SUBJECT: GRAND GULF NUCLEAR STATION, UNIT 1 - ISSUANCE OF AMENDMENT  
RE: IMPLEMENTATION OF ALTERNATE SOURCE TERM LIMITED SCOPE  
APPLICATION FOR THE TIMING OF THE ONSET OF GAP ACTIVITY  
RELEASE (TAC NO. MA4252)

AMENDMENT TO FACILITY OPERATING LICENSE

SAFETY EVALUATION BY THE OFFICE OF NUCLEAR REACTOR REGULATION  
RELATED TO AMENDMENT NO. 143 TO FACILITY OPERATING LICENSE NO. NPF-29

GRAND GULF NUCLEAR STATION, UNIT 1

**Figure 1** Core Average Axial Power Distribution Used in TRAC-BF1 Analysis

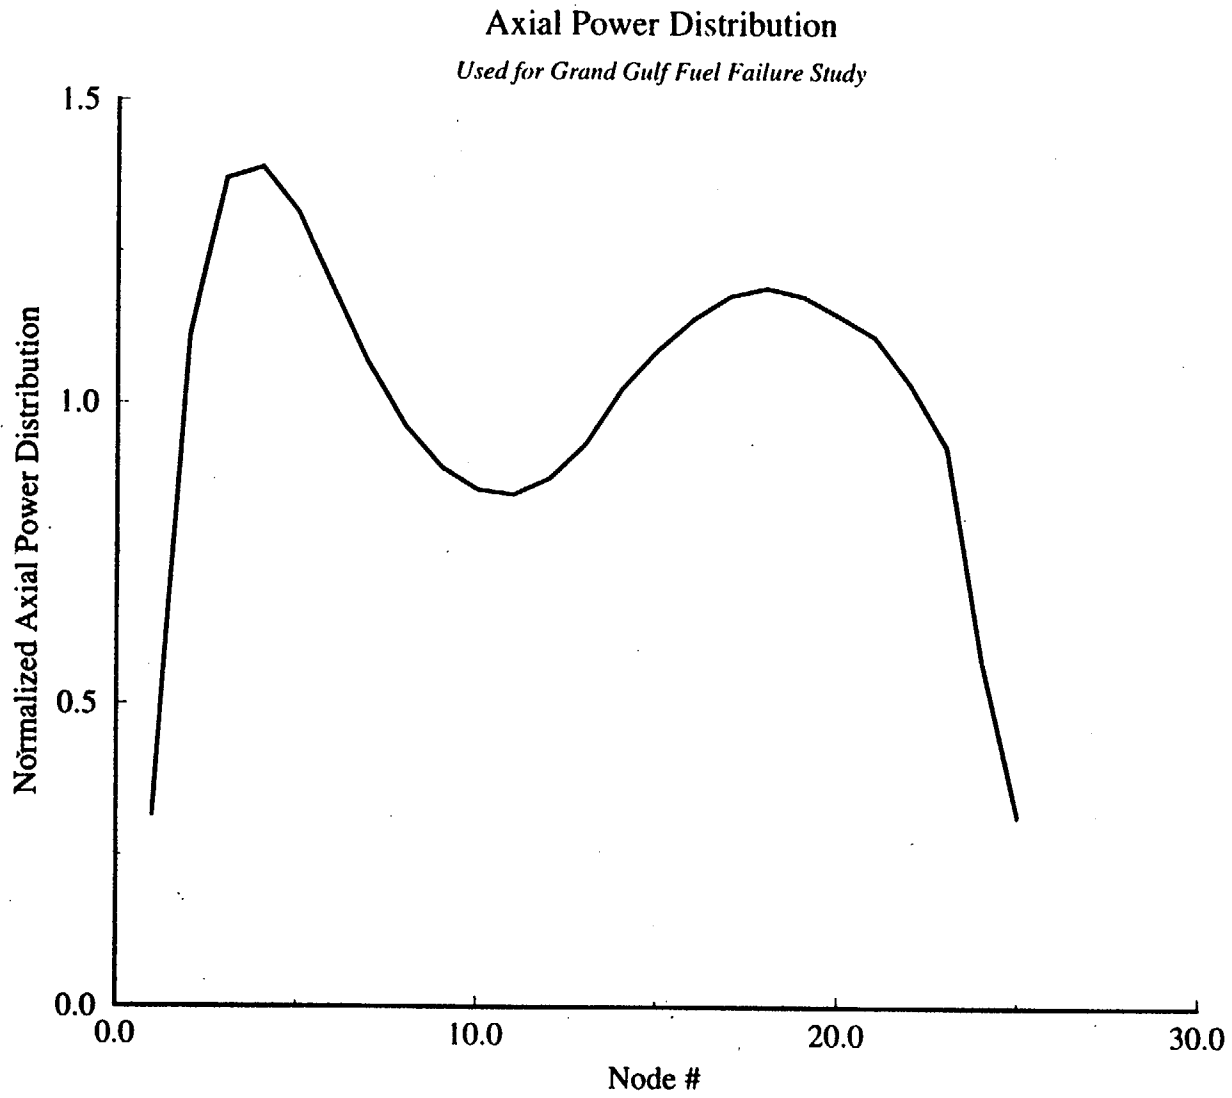
The staff obtained a GGNS input deck originally prepared by INEEL. This deck was written for a previous version of the TRAC computer code and, therefore, had to be modified to run with the BF1 version of TRAC. All of the plant geometry was retained with the exception of the jet pumps. The staff used a jet pump model, which was extracted from another BWR/6 input deck, and changed the number of jet pumps to correspond to the number at GGNS. The deck consists of 46 components. The major parameters used in the deck are given in Table 1. The staff used information from the most recent core operating limit's report dated August 13, 1997 (Reference 6), to determine the fuel type being used at GGNS, and used the staff's lattice physics methods to predict radial peaking factors for use in the CHAN component type. The part length fuel rods were not modeled and the internal water channels were modeled with water pins. The axial power distribution is shown in Figure 1 and the remaining kinetics parameters were taken to be the default values.

**Figure 2** TRAC-BF1 Predicted Peak Cladding Temperatures for Grand Gulf Design Basis LOCA with no ECC Injection

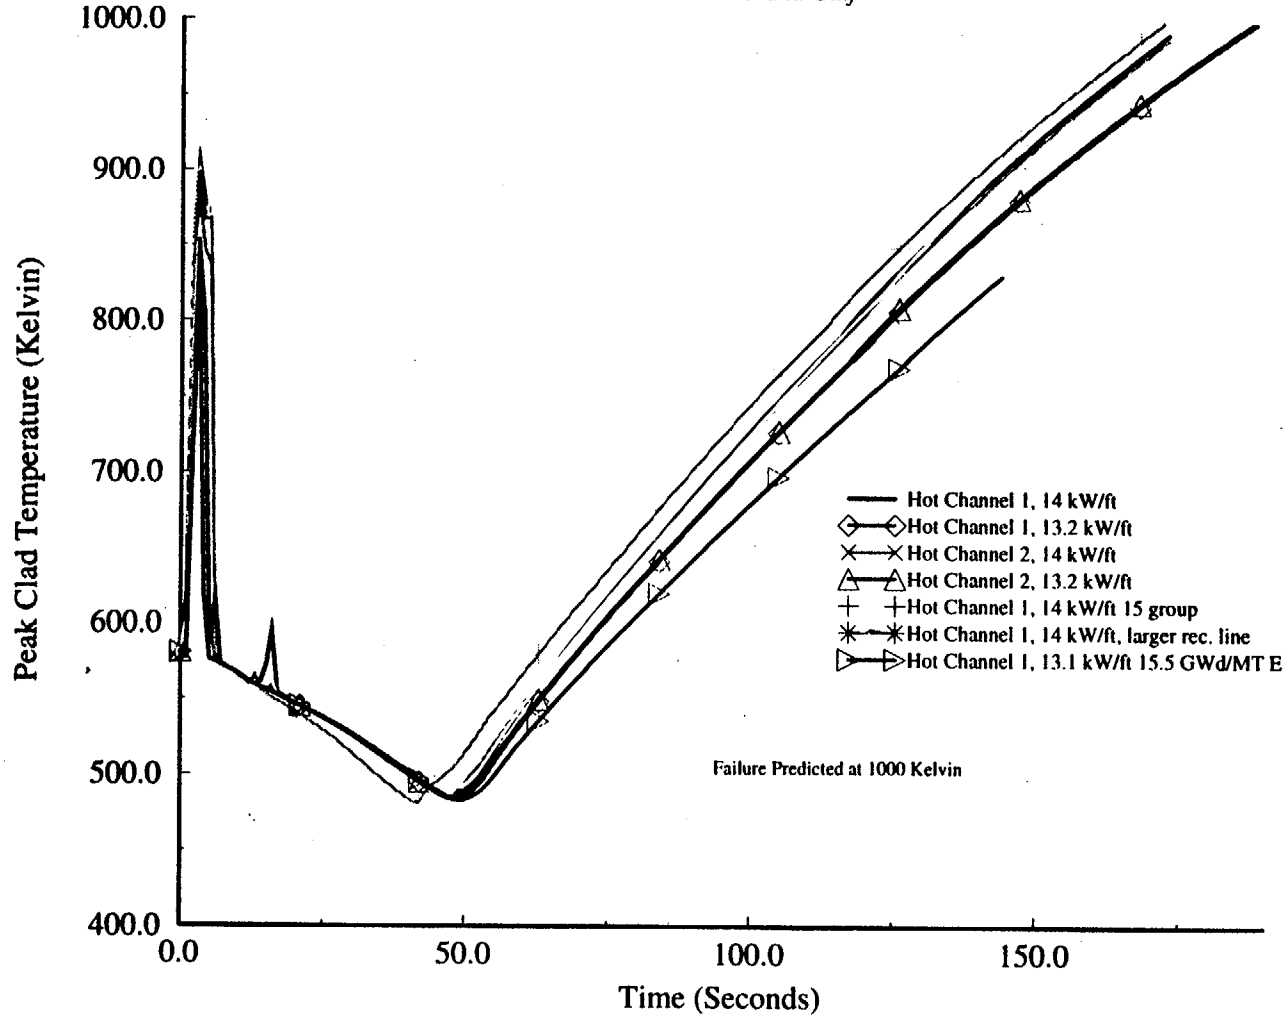
The PCT as a function of time is presented in Figure 2. As shown in the figure, the minimum time to failure is estimated to be 172 seconds. In order to confirm that the model is behaving as expected, the staff also examined the steam dome pressure (Figure 3) and the break flows (Figure 4), and confirmed that the ECCS injection flows were zero by examining the computer output file.
